8.2 Master Responses

8.2.1 Master Response 1: EIR/EIS Authorship

8.2.2 Master Response 2: Source Water Components and Definitions

205335.01 Monterey Peninsula Water Supply Project
Figure 8.2.14-1
CalAm Easement and Access at CEMEX

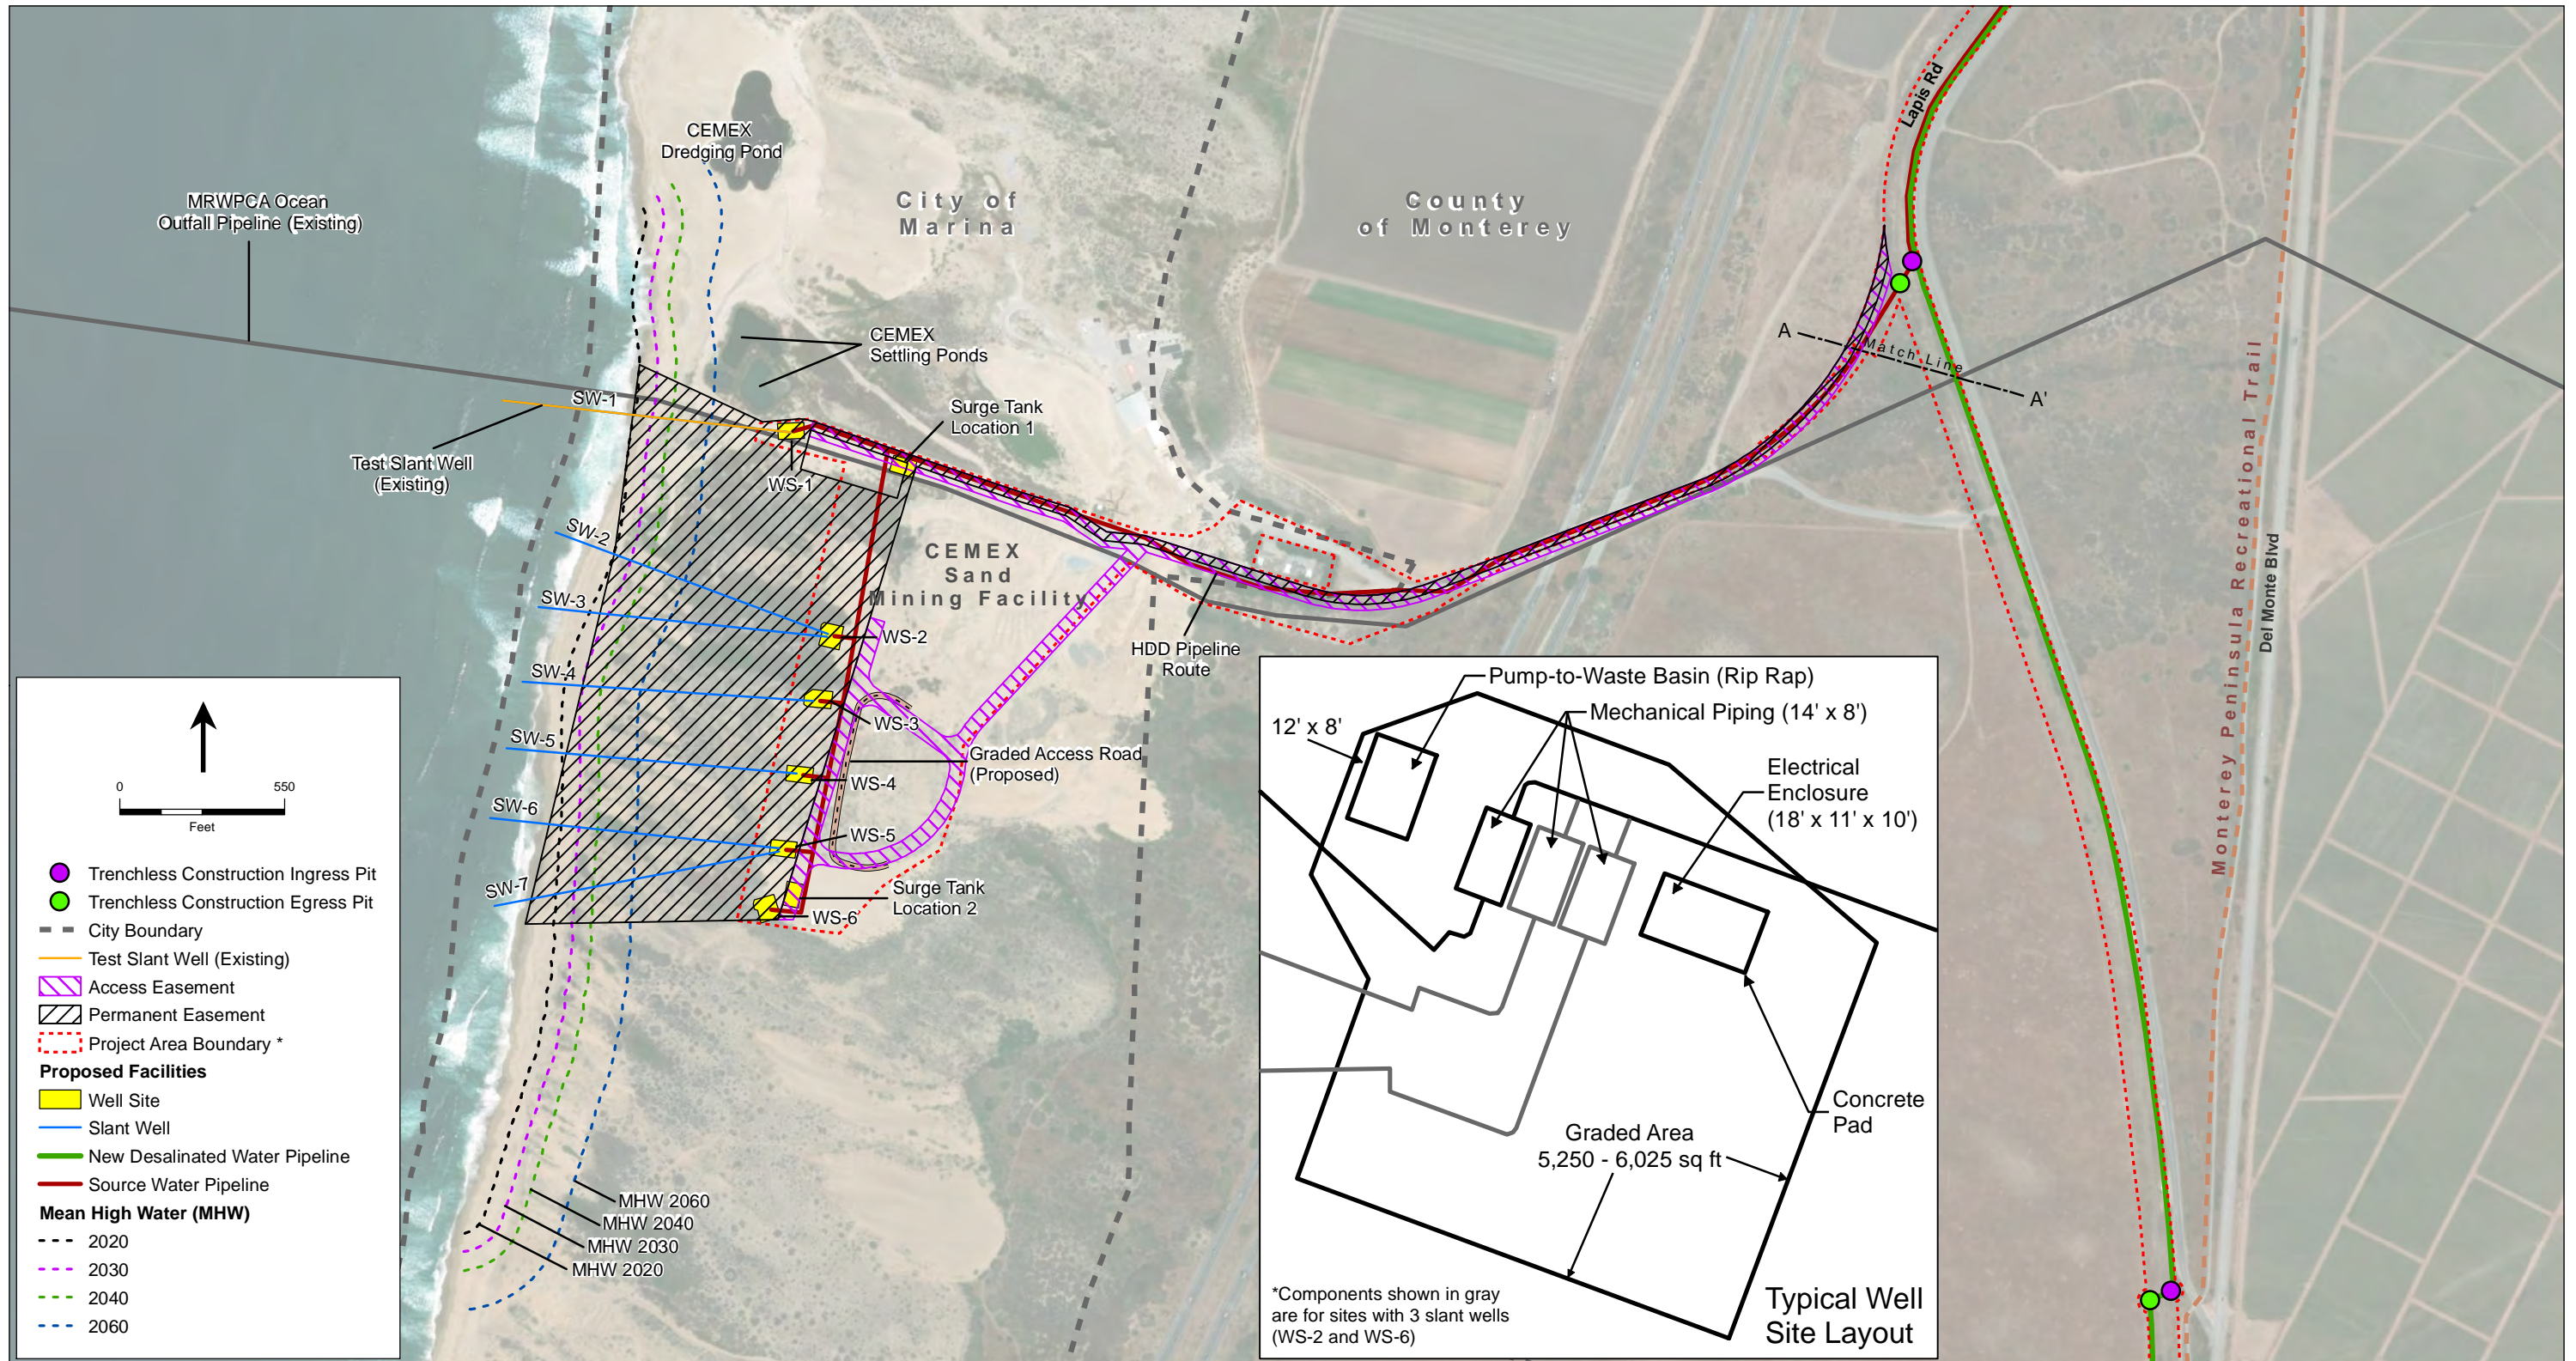
(ocean-side) of the dunes for about 1,800 feet before turning inland (east) for about 700 feet, then turning north for about 1,500 feet where it would intersect with the existing access road about 800 feet inland from the beach. CalAm would also maintain an additional 30-foot-wide easement along approximately 4,000 feet of the Source Water Pipeline alignment for another approximately 3 acres. See **Figure 8.2.14-1**.

As described in EIR/EIS Section 3.4.1, the analysis assumes that CalAm maintenance workers would access the slant wells via the existing CEMEX access road. Access to the CalAm easement across the CEMEX property is provided for in the CalAm-CEMEX Agreement. Section 3(h) of that agreement specifies that CalAm and CEMEX will determine a route for a vehicular access easement across the greater CEMEX property to the CalAm easement (see Figure 8.2.14-1), although CEMEX retained the right to relocate the vehicular access easement at any time so long as CalAm is provided with equivalent access to its easement. If the vehicular access easement is relocated such that the existing access road is no longer used, the new route would still be within the area analyzed as the extent of project disturbance and shown on EIR/EIS Figure 3-3a. Since the Settlement Agreement allows for public access and low-impact passive recreation on the property (Settlement Agreement Sections 6.1, 6.2(D)(3)), the new owners of the property will likely prepare a public access plan. Pursuant to Section 23.2 of the Settlement Agreement and the terms of the CalAm-CEMEX Agreement, the new owners and any public access plan would necessarily respect the access provision of the CalAm-CEMEX Agreement. Therefore, the assumptions regarding ongoing access to the slant well sites for project maintenance have not been changed in the Final EIR/EIS.
